**CBD & SOUTH EAST LIGHT RAIL PROJECT (SSI 6042)**

**CBD & SOUTH EAST LIGHT RAIL PROJECT (SSI 6042)**  
**SUBMISSION ON BEHALF OF BOLTED PTY LTD & ACTIUM PROPERTIES PTY LTD**

**Figure 1** – 4-12 Doncaster Avenue, Kensington

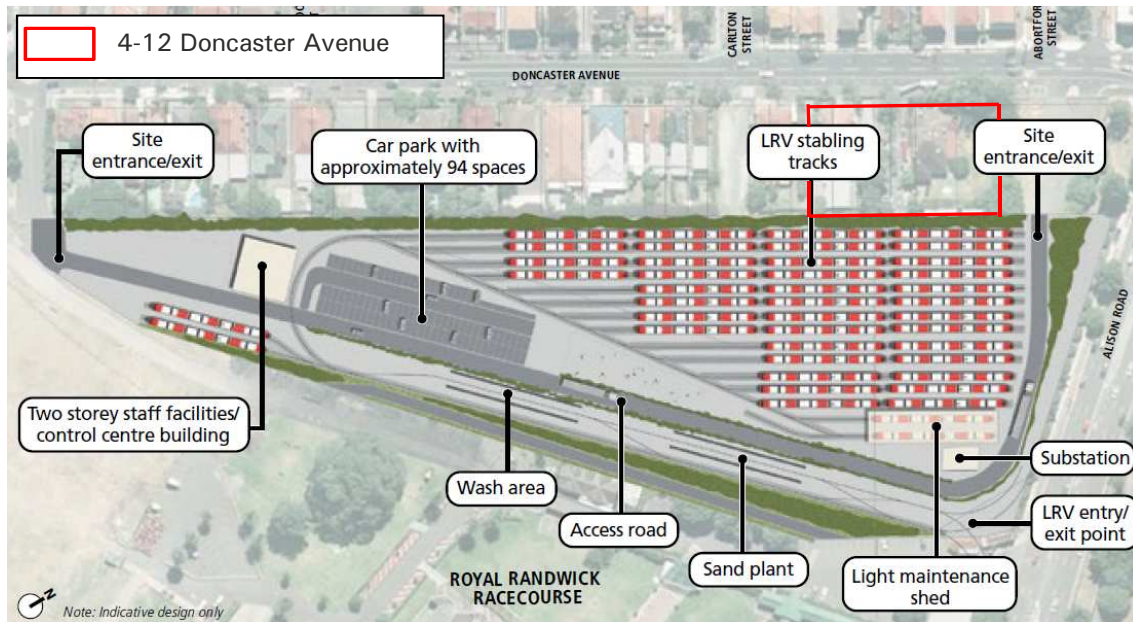
4-12 Doncaster Avenue is located on the western edge of the Randwick Racecourse (see **Figure 1**). The site is made up of a number of allotments, with a total area of approximately 3,080m<sup>2</sup> and a total frontage to Doncaster Avenue of approximately 77 metres. Existing on the site at 4-8 Doncaster Avenue is a single-storey dwelling. A pair of heritage listed two-storey terraces is located at 10-12 Doncaster Avenue.

**Figure 4** – Sight lines to substantial trees from Gate 19 on Doncaster Avenue

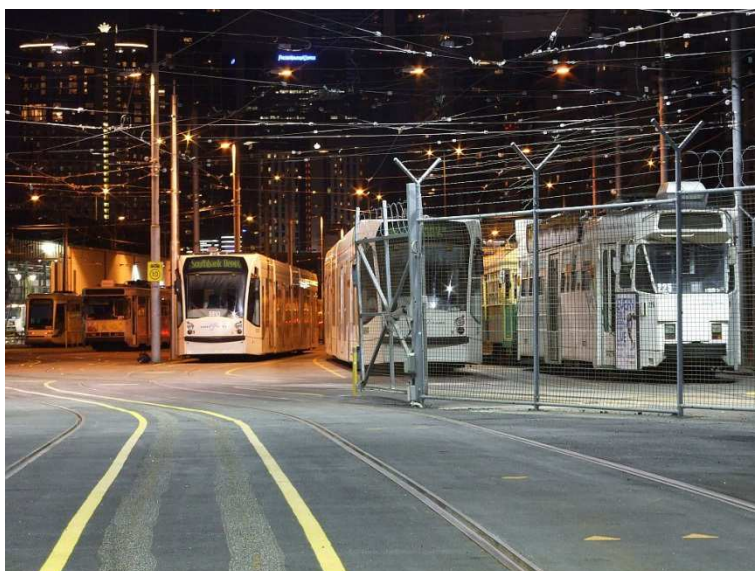
Figures 3 to 5 are photographs of the existing substantial trees that are proposed to be removed from the stabling facility land. Replacing these trees with an industrial stabling yard is a highly negative outcome for current and future residents of 4-12 Doncaster Avenue. Examples of stabling facilities are provided in Figures 4 and 5. Figure 4, while a train stabling yard, provides an indication of the view that will likely be imposed upon current and future residents. Figure 5, a light rail stabling yard, shows an extensive network of overhead wiring which will be prominent in the view.
